PRODUCT CHANGE NOTIFICATION

#PCN-TT-R1J5-15

Business Unit	Product Line Code	Type of Change	Action	Date of issue
TT	CL1	Aesthetic	Notify	10/27/2015
			Distributors	
			and Field

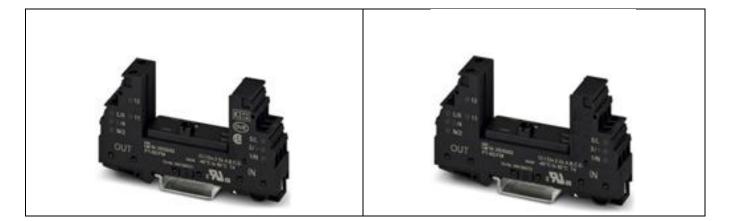
The PT-BE/FM (2839282) base element that was used with the discontinued PT 2-PE/S plugs (2839318, 2839321, 2839334, 2839347) is no longer KEMA and ÖVE approved. These plugs are replaced by their PLT-SEC counterparts that will utilize the PLT-SEC-T3-BE (2905557) base element. This grey colored base element is technically identical and is KEMA approved.
